Design Exception #3

Reducing the Buffer Area at MP 188 to 190

**I-70 West Vail Pass Safety and
Operations Improvements**

DESIGN EXCEPTION MEETING
AUGUST 2, 2021

Exhibit C (1 of 3)-
Context Sensitive Solution
Median Design Exception
Mile Post 188.8 to 190
07-20-2021

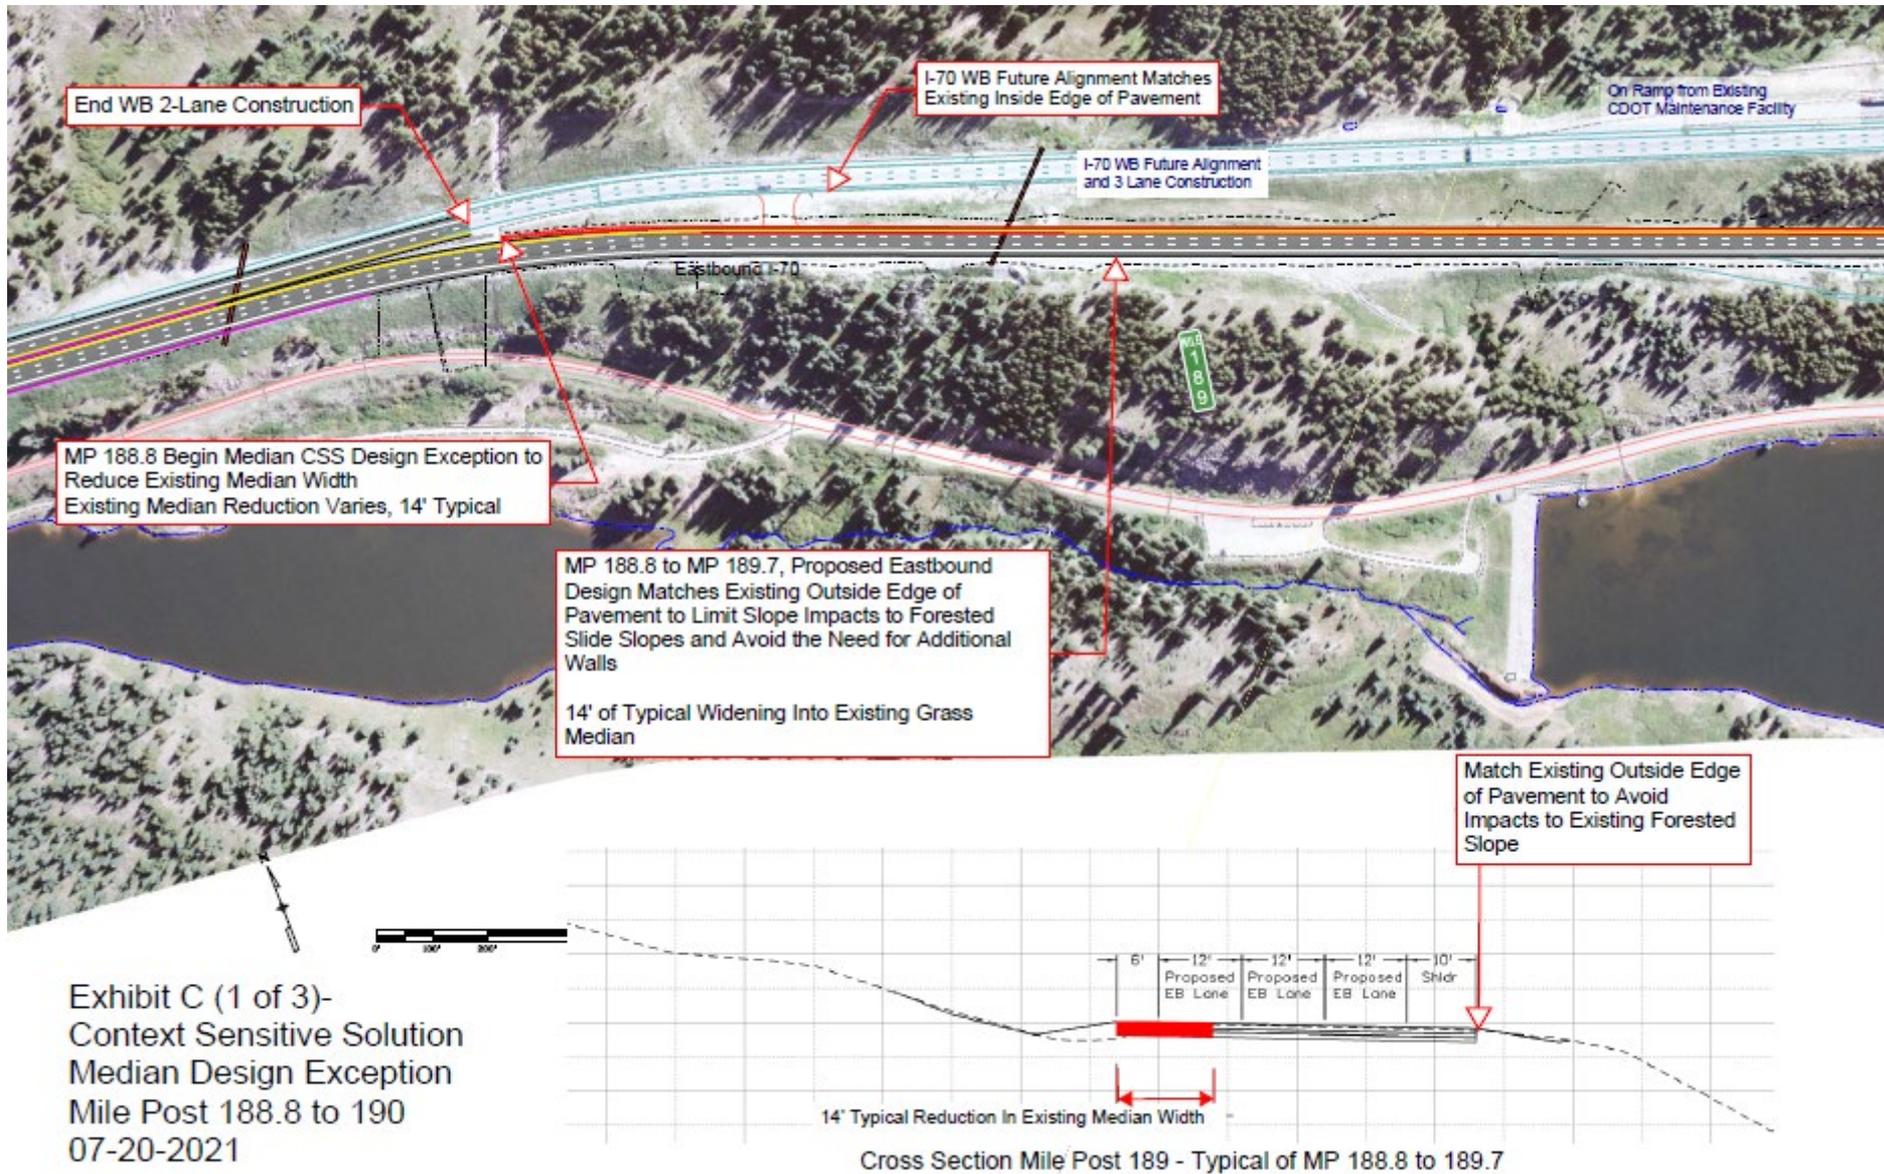
Matching the existing outside edge of pavement and widening 14' into the median is consistent with the roadway geometry.

This alignment allows the existing truck parking to remain in place.

4. Michelle said she didn't see any of the wildlife crossings identified at 188.7, 189 or 189.6.

Brian said they are there, they just aren't called out because he was trying to highlight the roadway.

Exhibit C (1 of 3)-
Context Sensitive Solution
Median Design Exception
Mile Post 188.8 to 190
07-20-2021

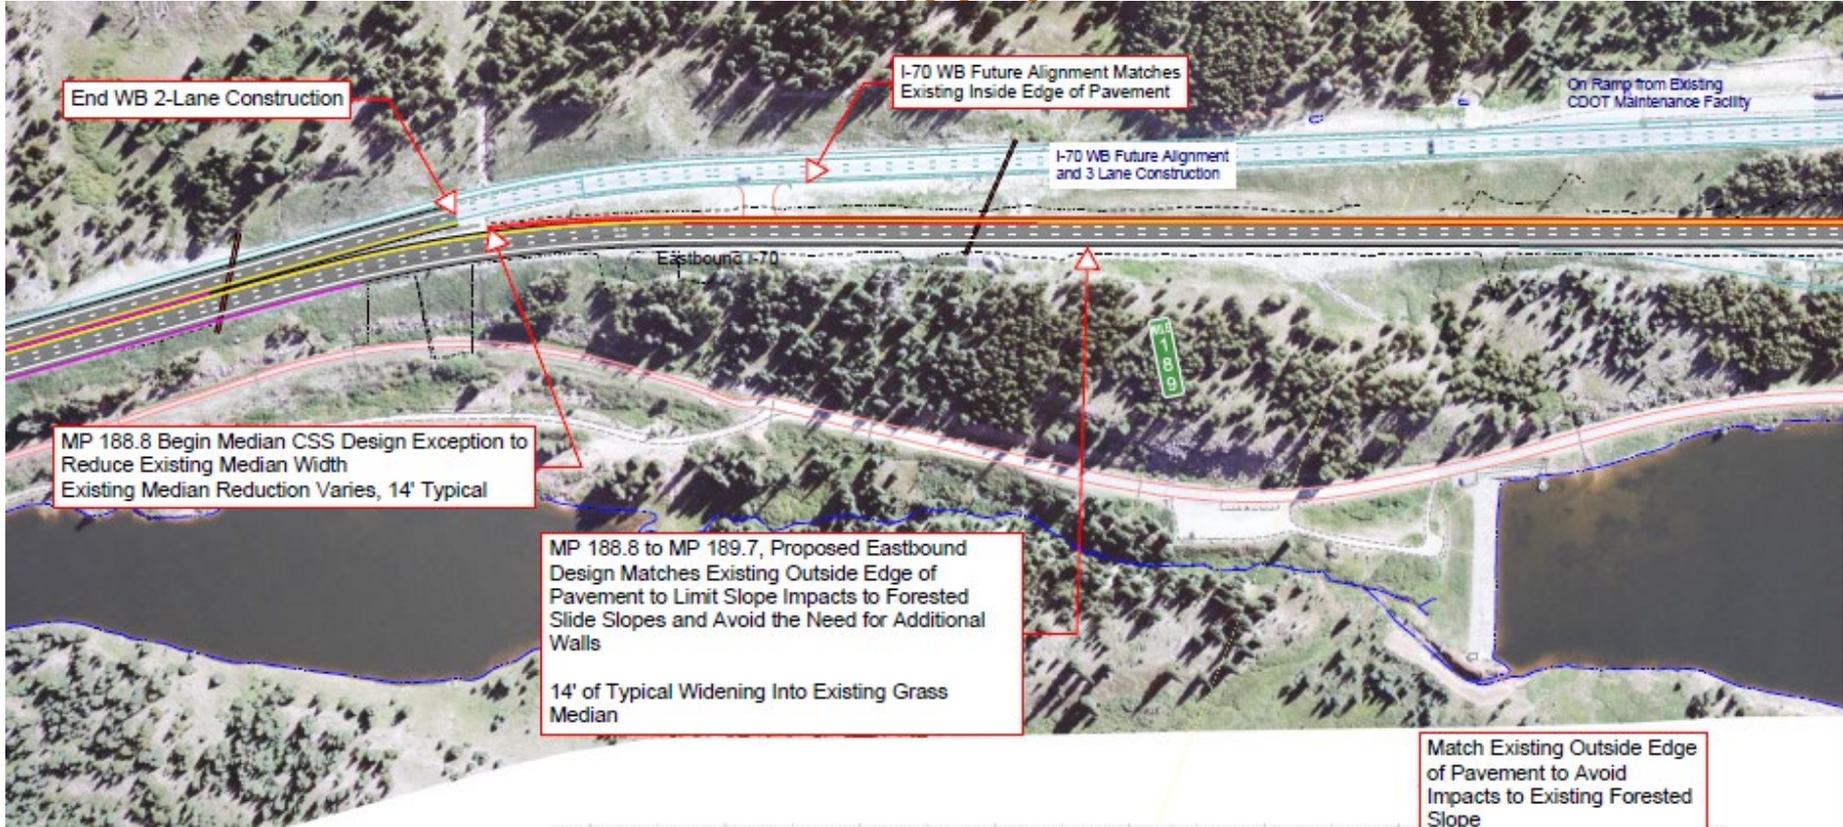
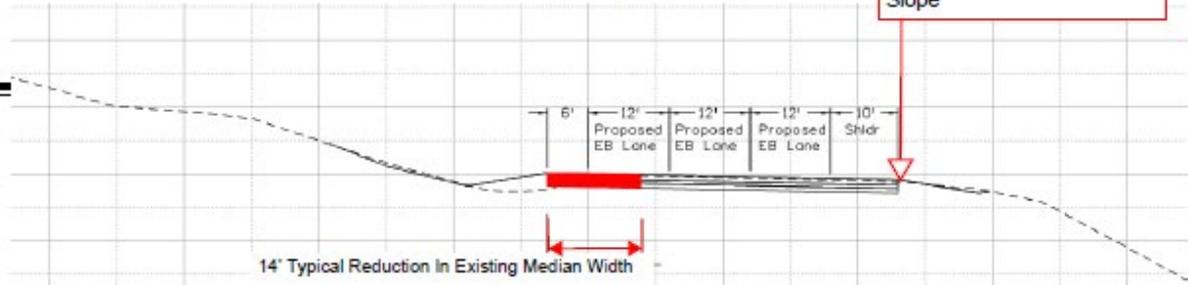
a. The Design Exception meeting was earlier this week and we asked for support for median reductions. The design criteria state you cannot reduce the width of the median. When we looked at trying to balance of all of the issues such as disturbance area, impacts to wetlands and impacts to the trail, we found that narrowing the median in certain locations is really the optimal option for the roadway design.

i. This design exception is from MP 188.0 to MP 190.1. In this area we are holding the southern edge of pavement and widening into the median. It protects the slope, and the forested areas and we didn't want to get any closer to Black Lake. John said it will leave room for water quality features on the south side in those areas where we are still refining and designing right now. There is also another wildlife crossing that is in the area.
